Access Compliance Report Public Rights-of-Way (Curb Ramps)

Main Street: BOW_PL Cross Street: LASSEN_DR Location: NE

ADA ID: RPAT211025092141 Ramp Type: Type 3 - Combination 1 Initial Pass/Fail: Fail Overall Compliance: No Severity Score: 5

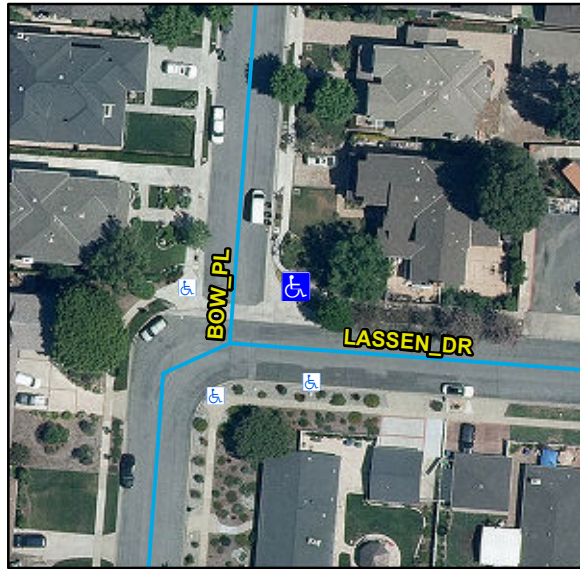
R304.5.1, R304.5.3, STD 1115

Compliance	Description	Data	Compliance	Description	Data
N/A	Ramp Length LT (in)	106	N/A	Ramp Length RT (in)	85
No	Ramp Width LT (in)	36	Yes	Ramp Width RT (in)	50
Yes	Ramp Run Slope LT (%)	8.3	Yes	Ramp Run Slope RT (%)	5.2
No	Ramp Cross Slope LT (%)	4.3	Yes	Ramp Cross Slope RT (%)	0.8
N/A	Ramp Length (in)	63	N/A	Flare Type LT	
Yes	Ramp Width (in)	49			N/A
Yes	Ramp Run Slope (%)	5.6	N/A	Flare Slope LT (%)	N/A
Yes	Ramp Cross Slope (%)	0.7	N/A	Flare Traversable LT	N/A
N/A	Landing Present	N/A	N/A	Flare Type RT	
N/A	Landing Length (in)	N/A			N/A
N/A	Landing Width (in)	N/A	N/A	Flare Slope RT (%)	N/A
N/A	Landing Run Slope (%)	N/A	N/A	Flare Traversable RT	N/A
N/A	Landing Cross Slope (%)	N/A	N/A	DWS Provided	N/A
N/A	Landing Movement Obstructed?	N/A	N/A	DWS Contrast	N/A
	Landing Movement Type	N/A	N/A	DWS Length (in)	N/A
N/A	Landing Shared	N/A	N/A	DWS Full Width	N/A
N/A	Clear Space	Yes		DWS Offset Type	N/A
N/A	Clear Space To Crosswalk (in)	N/A	N/A	DWS Offset Left (in)	N/A

Remove & Replace Curb Ramp With Two New Directional Ramps or Equivalent.
